Responses to Anonymous Referee #2

MS No.: hess-2020-59

Fig. 1 Illustration of the water simulation process between ground surface, inlet, sewer pipe and manhole.

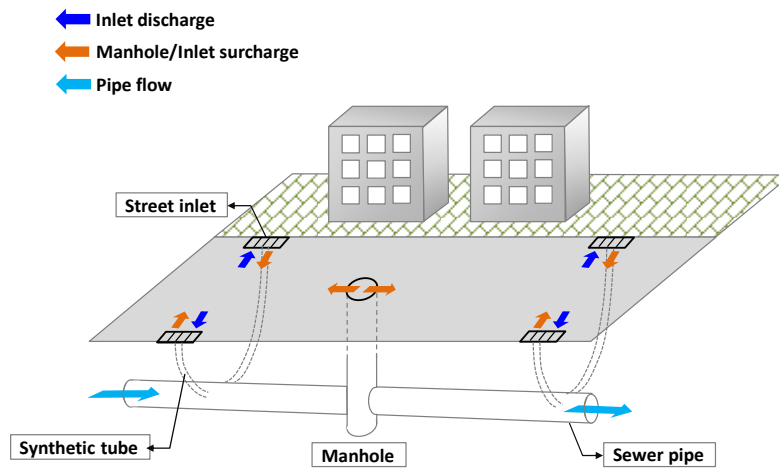
Very little information about the model is given in the paper. The reader is referred to 2 other papers (Jang et al. 2018 & 2019). The effort made not to be redundant is appreciated, but some more details are needed about: 1) the numerical coupling 2) the manholes location and implementation in the model 3) the chosen hydraulic parameters, roughness distribution, boundary conditions. . . 4) the time extent of the simulation.

- (1) When rain drops, the OFM is firstly initiated for surface water routing. Then, the surface runoff travels for a distance and enters the sewer pipes via the street inlets to trigger the SFM. When the sewer pipes get full, the sewer water surcharges back onto ground surface via the manholes or inlets. In the simulation process, the water exchanges between the two models are realized by adding a source/sink term in the continuity equations which can be determined by weir and orifice functions via one-to-one relationship as shown in the schematic diagram Fig. 1.

Fig. 2 The pipeline and manholes of the sewer systems in the study area.

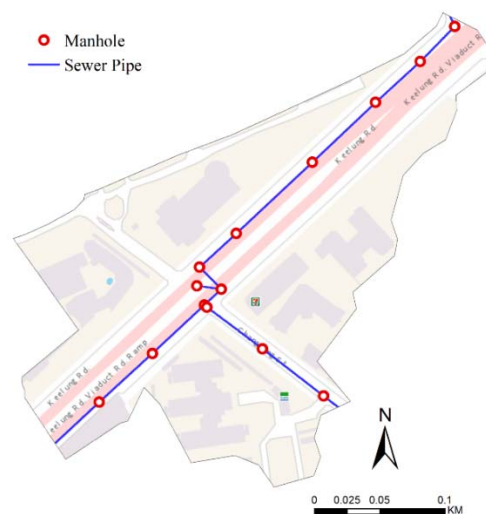
23. Section 2.3 This section lacks details about the chosen hydraulic parameters CFS model (roughness, boundary conditions) for both OFM and SFM. It is not clear how the manhole positions are determined: DEM and water levels are obtained from images, why not the manholes? It is also not clear which type of interaction between OFM and SFM is applied. The authors should also give the time limits of their simulations.

- (2) The pipelines and manholes of the sewer systems are obtained from governmental filed survey data and are displayed in Fig. 2.

Response: The pipelines and manholes were obtained from the field survey data provided by the local government. Please see the responses to the specific comments about Section 2.2 for details.

Fig. 3 Conceptual flowchart of this study (the VGI photo was adopted from PTT, Taiwan)

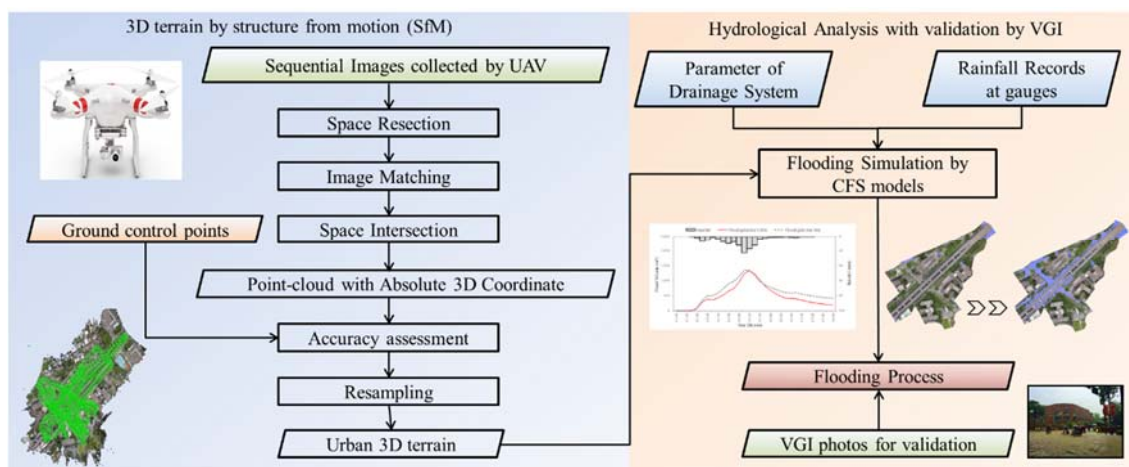
7. 1.79 “finally, the simulated results are compared” Contradiction with fig. 3 where VGI seems to be an input to the CFS.

Response: Thanks for pointing this out. The revised figure is shown in Fig. 3.

Fig. 4 The rainfall hietograph on 14 June 2015 at GongGuan rain gauge station (C1A760).

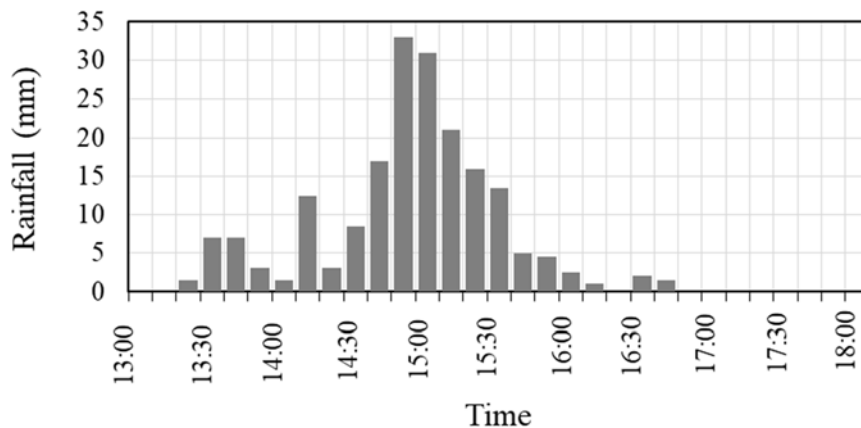
38. Figure 1 Caption: rain gauge (as in the text). In the bar chart, times are written above bars, I guess they should lie between bars

Response: Thank you for the comment. The term “rain gauge” and the revised figure is shown in Fig. 4.

Fig. 5 Study area (red polygon) at GongGuan, Taipei, Taiwan (the Google Earth images sourced from © Google, Landsat/Copernicus and the DEM in the top left image and the hillshade in the top right image were derived from SRTM with 30 meter resolution).

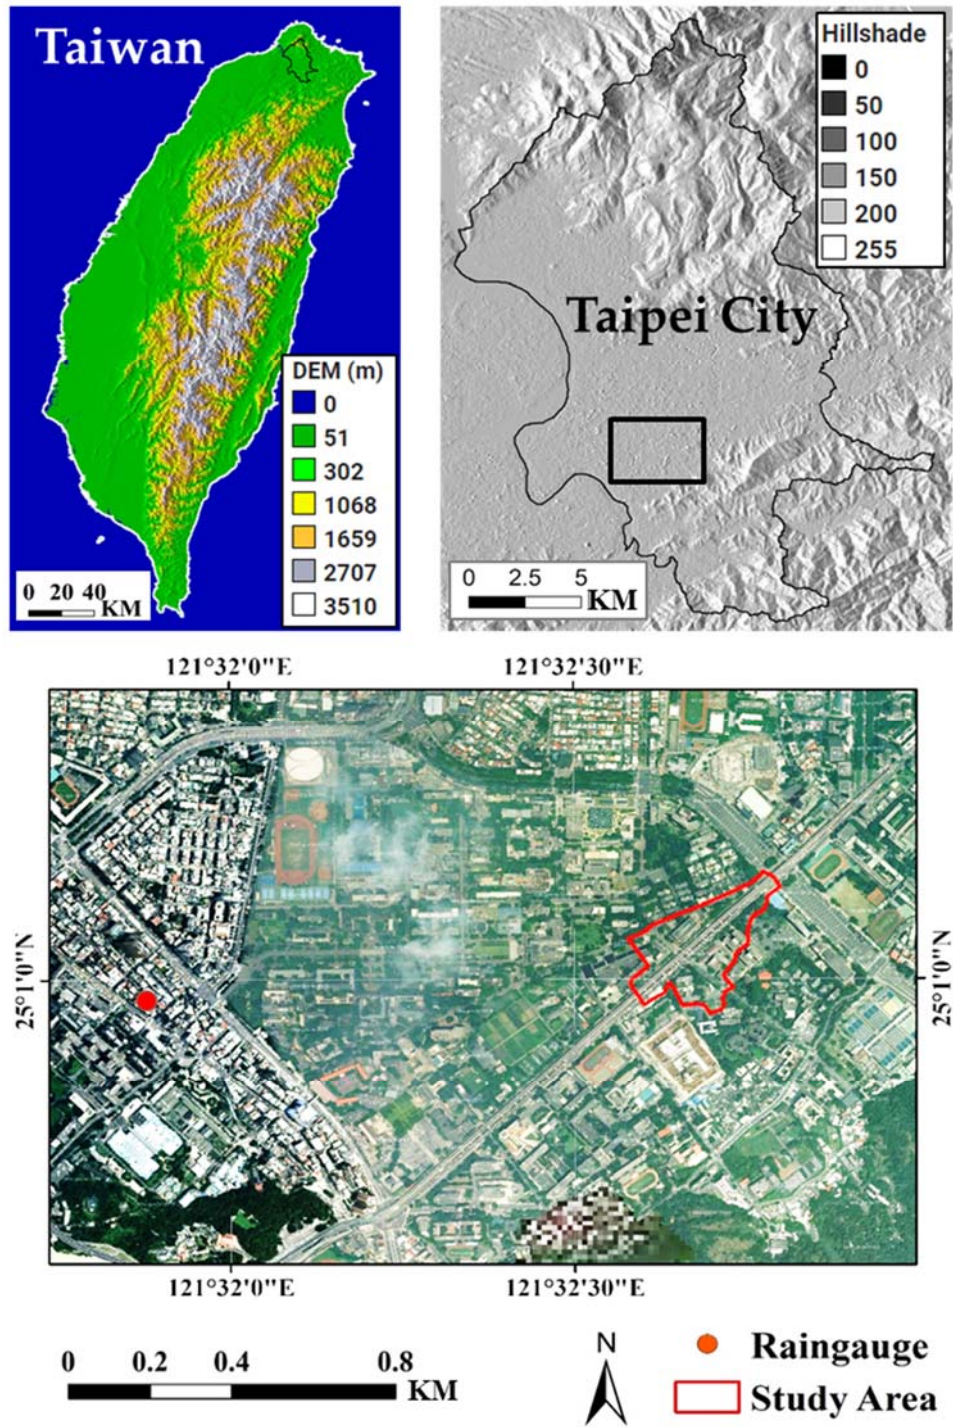
39. Figure 2 Rain gauge (as in the text). Top left image is not necessary. I do not understand the gray levels in top right image : shade or altitude? Bottom image is very dark, authors should improve brightness and contrast. The cartographic scale is indicated only for the bottom image Figure 3. The right part is not consistent with the paper. VGI seems to be an input of CFS. Parameter of Drainage system: is there only one parameter? This parameter is not even mentioned in the paper.

Response: Thank you for the comment. Rain gauge has been corrected.

The Top left image is aiming to show the location of Taipei City in Taiwan. The gray levels in top right image shows the hillshade as it presented in the legend of this image. The bottom image has been adjusted to improve its brightness and contrast. A cartographic scale is also added to all the images (please see Fig. 5). The VGI is not an input of CFS so that the Fig. 3 is revised (see the response to Technical corrections #7). The parameters of the drainage system have been added (Please see the responses to the Specific comments about Section 2.2).

Fig. 6 Images taken by UAV and the distribution of the ground control points

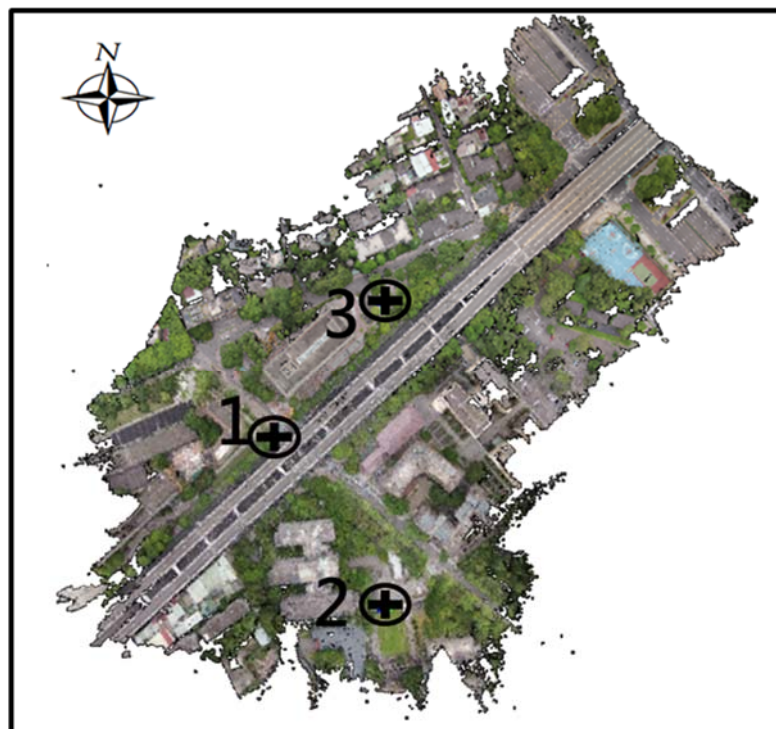
41. Figure 5 The caption reads: “images taken”, but they must have undergone some processing. The authors should tell readers what is exactly displayed in fig. 5. The image is distorted compared to the area shown in the following figures (stretched along Y axis). Why? GCP #1 is located just next to the viaduct, so there is a discontinuity in altitude just nearby. It is recommended to select clear zones for GCPs

Response: Thank you for the comment. The caption has been revised. We noticed that the image is distorted and it has been corrected (see Fig. 6). Since GCP #1 is about 10 m away from the viaduct, there is enough room to display the continuity of altitude.

Fig. 7 (a) Orthoimage; (b) the DEM with spatial resolution of 0.5 m; (c) the DEM with spatial resolution of 5 m

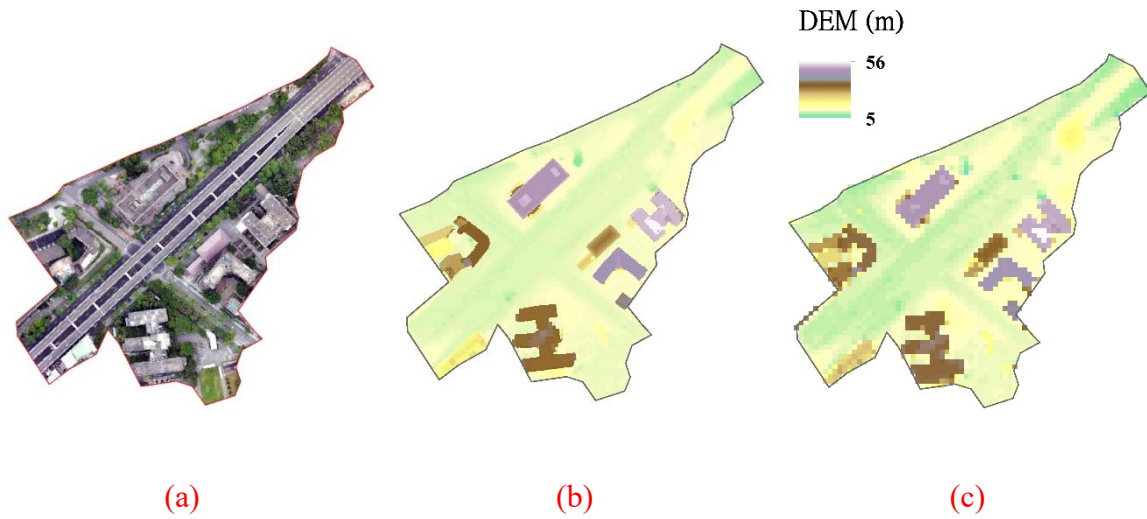
43. Figure 7 The choice of the color scale is not adequate to allow a good perception of low value altitudes (everything is blue). Moreover, the rainbow color scale should be avoided: <https://www.nature.com/articles/519291d> <https://www.climate-lab-book.ac.uk/2014/end-of-the-rainbow/>

Response: We have changed the color scale of this figure and also checked the image on the Coblis (<https://www.color-blindness.com/coblis-color-blindness-simulator/>). The revised figure

is shown in Fig. 7.

Fig. 8 Simulated flood extents at different time under DEM resolution 0.5 m (left) and DEM resolution 5 m (right).

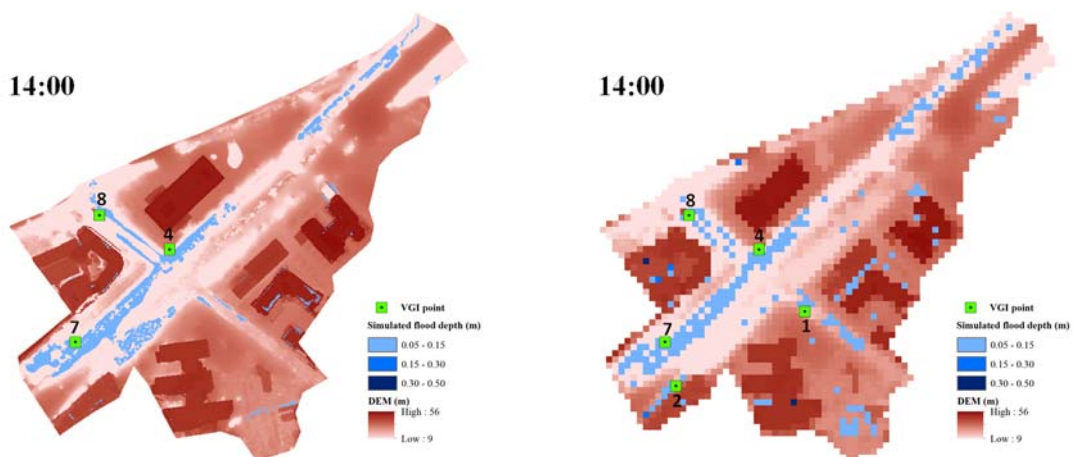
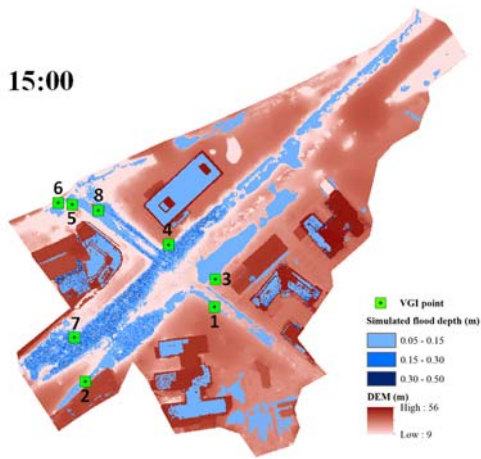
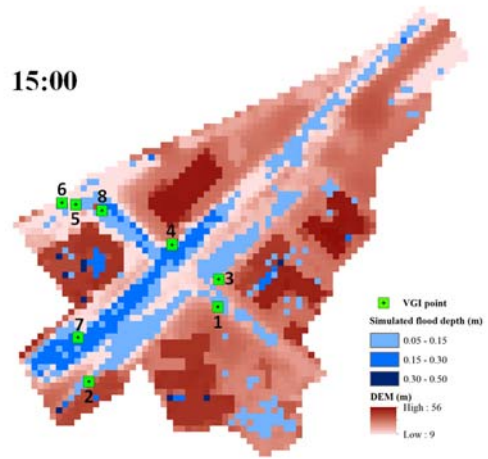
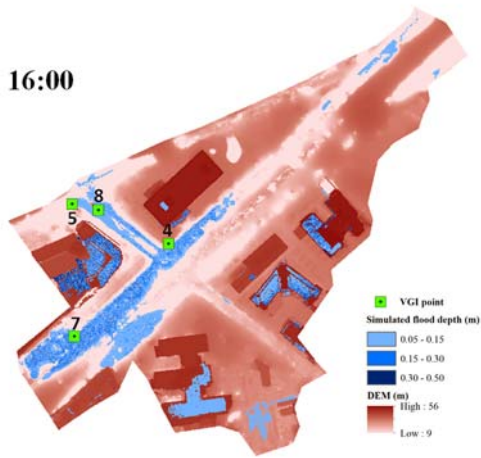
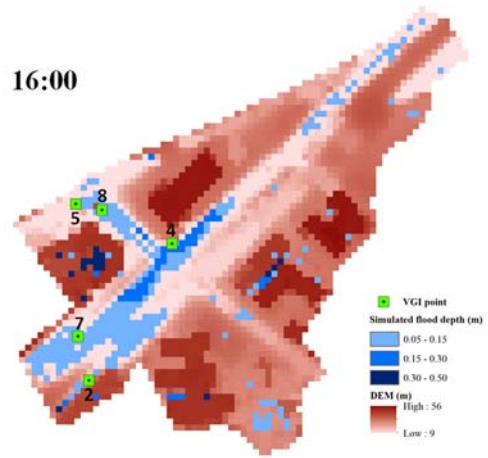
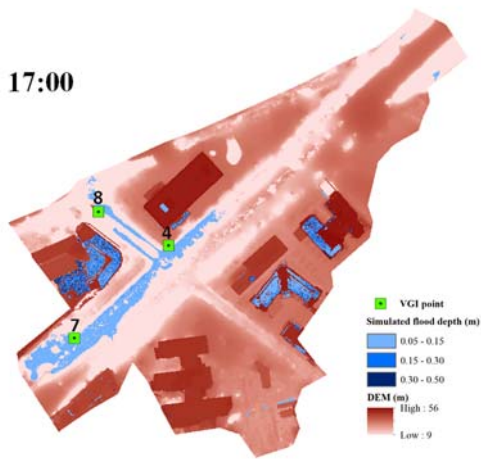
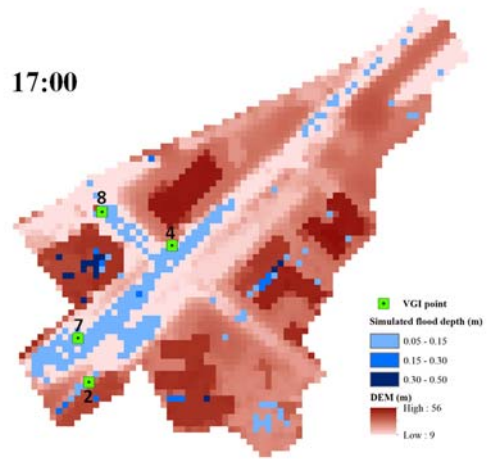
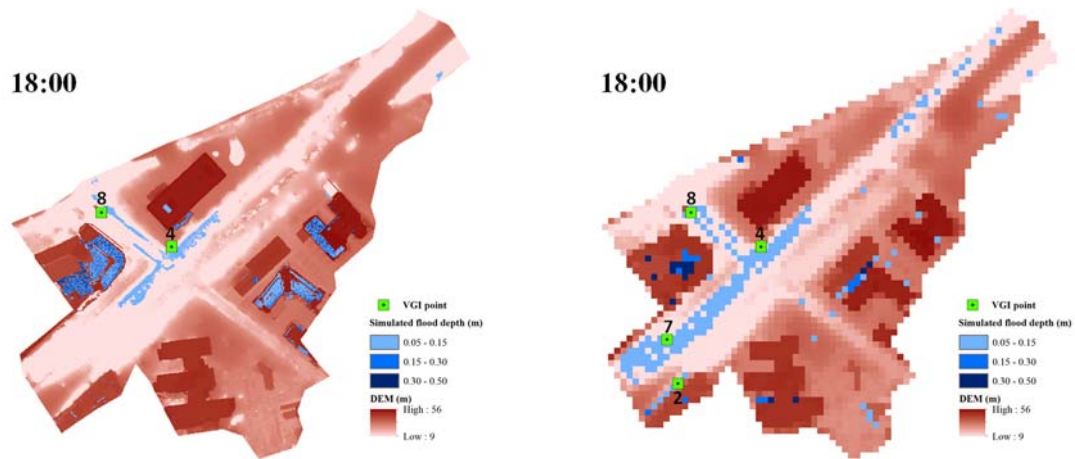
44. Figure 8 Water depths between 0.00 and 0.05 m should appear in white according to the caption. I can not see any white pixel. Why? The difference between the colors corresponding to 0.15-0.30 and 0.30-0.50 water depths is too small to be distinguished. Water accumulates on roofs, especially for the fine resolution model. It seems very unlikely, especially for the building lying in the left.

Response: Thank you for the comment. The depths between 0.00 and 0.05 m should appear as no color. We have corrected it and adjust the scaling of the figure to highlight the DEM characteristics on road surface (the revised figure is shown in Fig. 8). The difference between the colors corresponding to 0.15-0.30 and 0.30-0.50 water depths has been adjusted.

Fig. 9 Parapet wall around the border of building. (Image credit: good.ruten.com.tw)

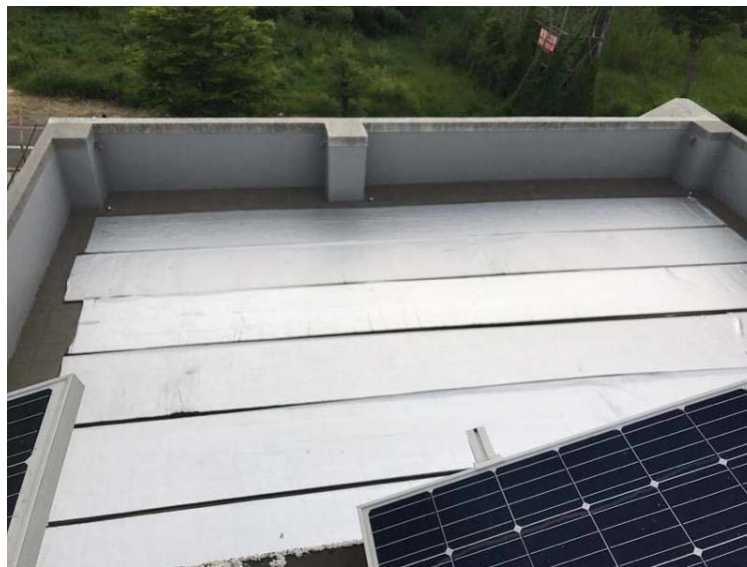
27. 1. 167-169 The authors state that water on rooftops is better simulated by the fine resolution model. Could they give some validation criteria to explain this statement? Could they explain why water should be on rooftops? Does their model take water evacuation from rooftops into

The water accumulated on rooftop is because there are solid parapet wall with about 1 meter height around the borders of these buildings. For example, it just like the parapet wall in Fig. 9.
